**AMENDMENT NO. 2 OCTOBER 2005
TO**

IS 2048 : 1983 SPECIFICATION FOR PARALLEL KEYS AND KEYWAYS

(*Second Revision*)

FIG.

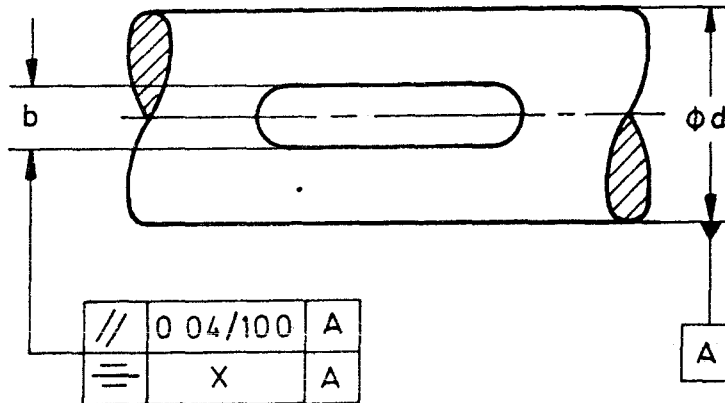
[Page 7, clause 6 (see also Amendment No. 1)] — Insert the following new clause 6 after 5:

6 ERROR OF SYMMETRY AND PARALLELISM

Diameter of Shaft	Above	10	12	17	22	30	38	44	50	58	65	75	85	95	110	130
	Up to	12	17	22	30	38	44	50	58	65	75	85	95	110	130	150
<i>b</i>		4	5	6	8	10	12	14	16	18	20	22	25	28	32	36
<i>X</i>		0.1			0.16		0.2				0.3			0.4
